Hi Jonathan – we are the owner/developer of the proposed Cloverleaf development in northern El Paso County. Thank you for your review comments dated 12/2/2020 as attached.

PRELIMINARY GRADING PLAN
 CLOVERLEAF DEVELOPMENT
 HIGBY ROAD & CLOVERLEAF ROAD
 MONUMENT, CO
 FOR: PROTERRA PROPERTIES, LLC

CGS provided comments on 10.5.2020 that remain valid and are repeated here:

**SOIL, GEOLOGY AND
GEOLOGIC HAZARD STUDY
CLOVERLEAF DEVELOPMENT
EL PASO COUNTY, COLORADO**

**ENGINEERING GEOLOGY MAP
 CLOVERLEAF DEVELOPMENT
 HIGBY ROAD & CLOVERLEAF ROAD
 MONUMENT, CO
 FOR: PT CLOVERLEAF, LLC**

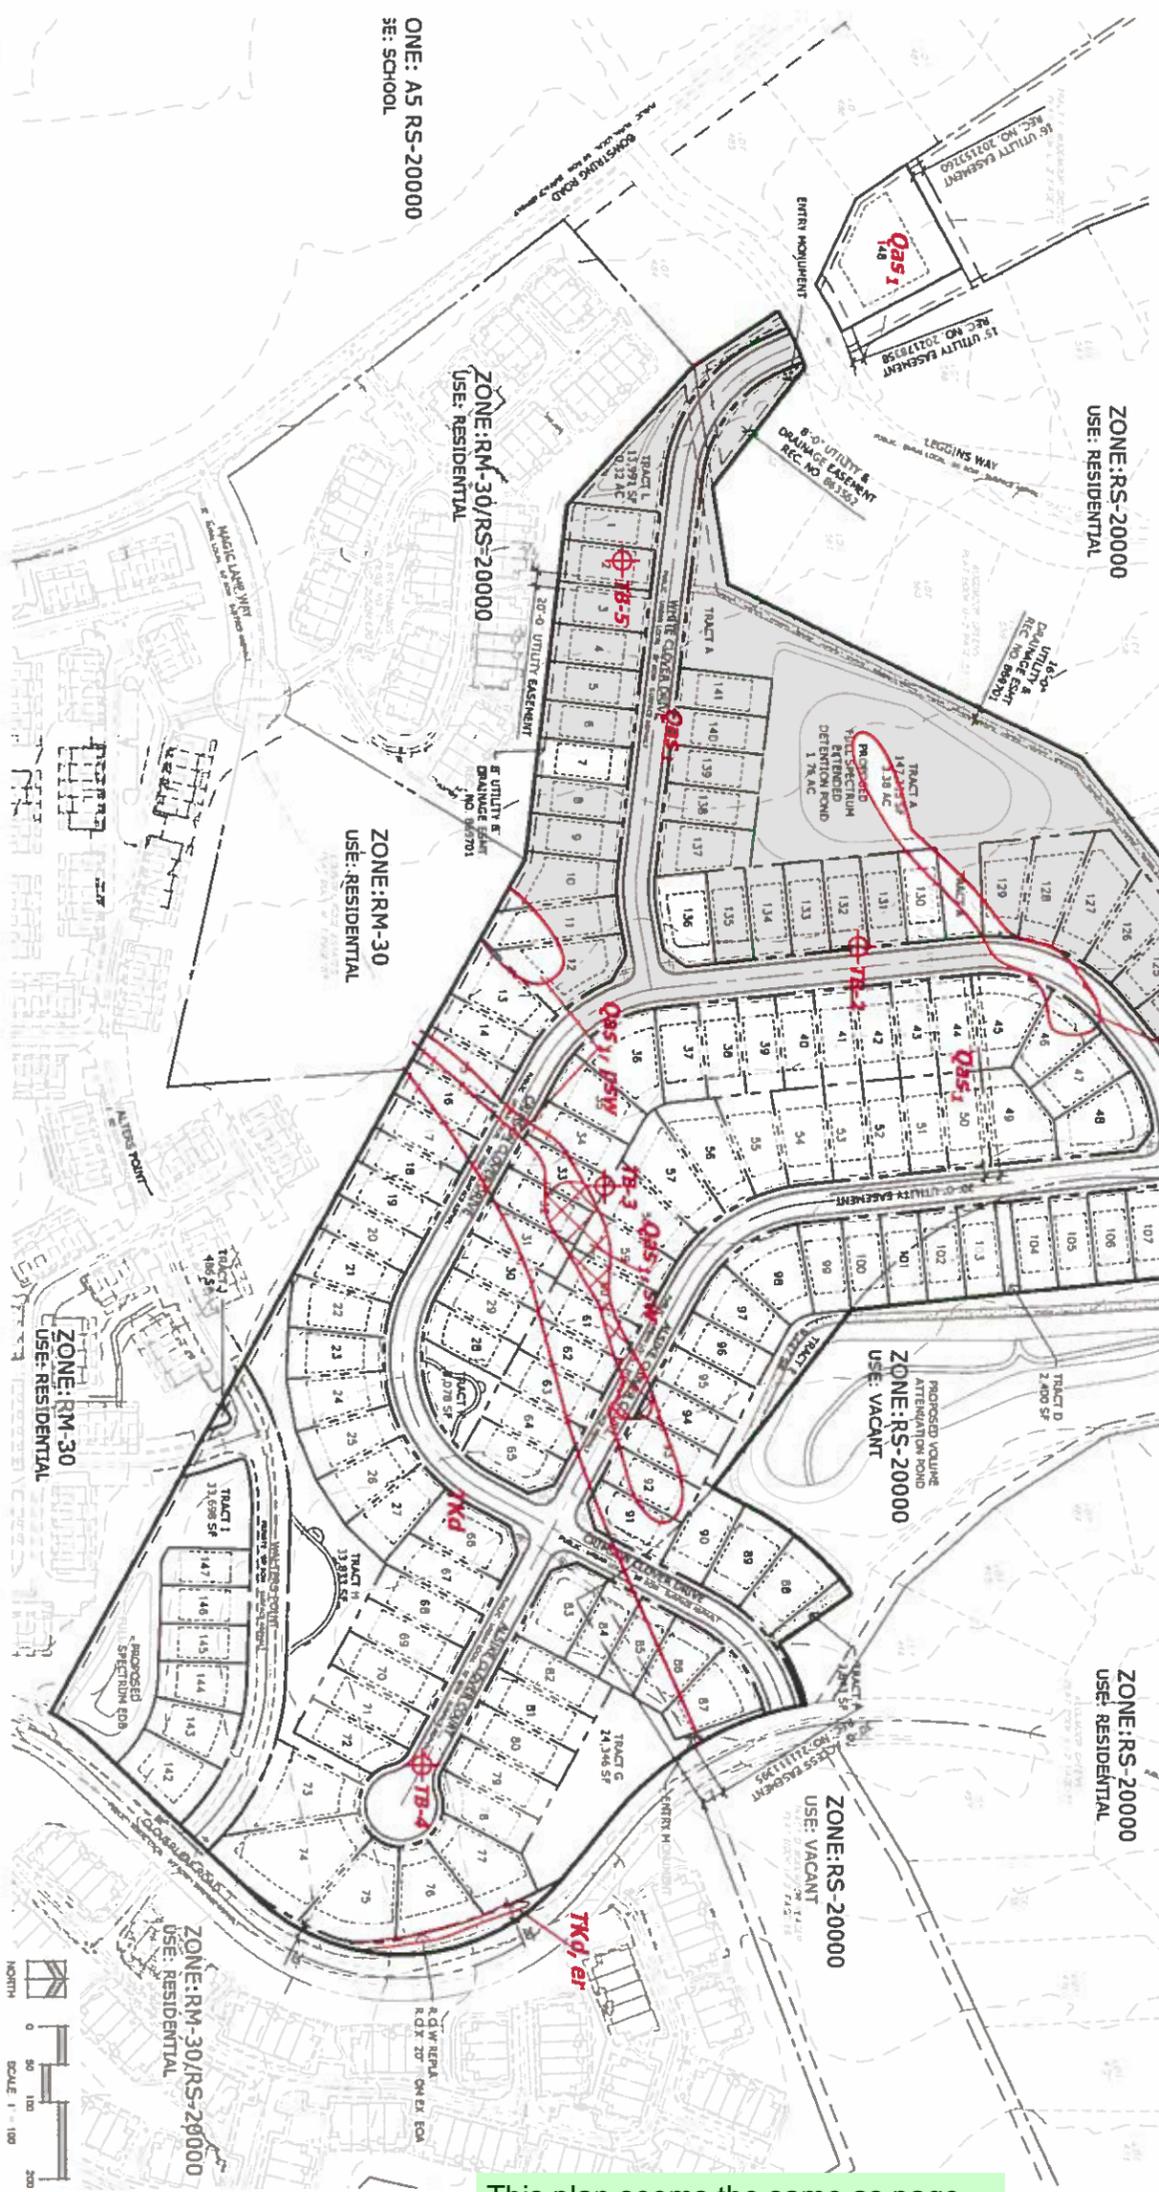
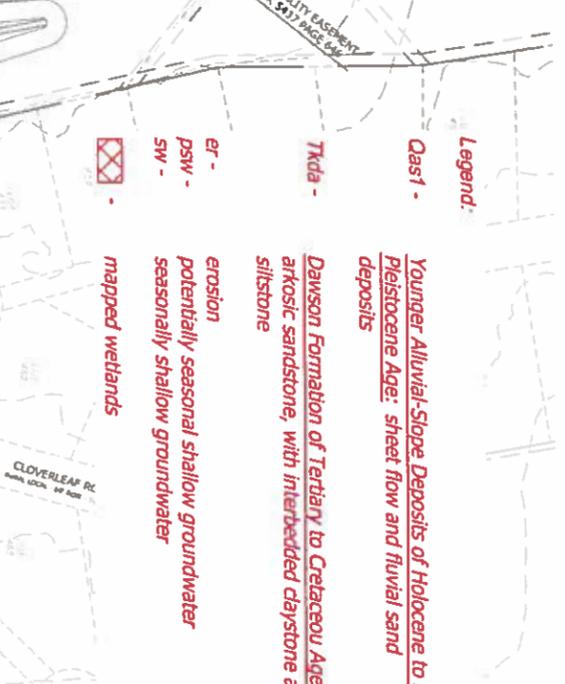
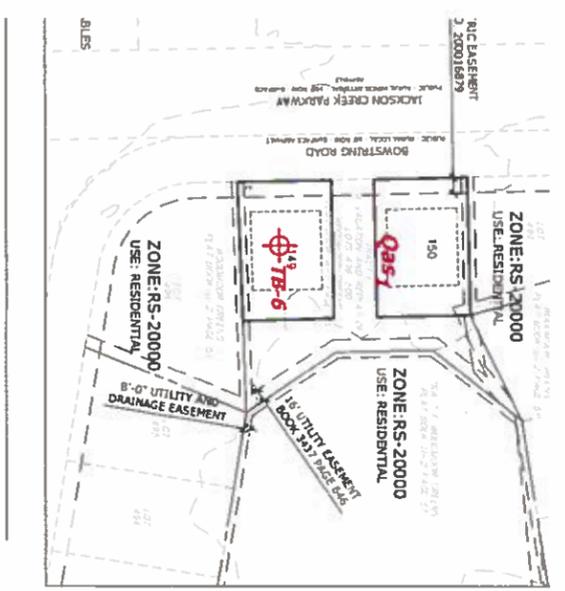
This plan seems the same as page 27 above but shows different test boring locations. The report references 6 test borings so which map is accurate?
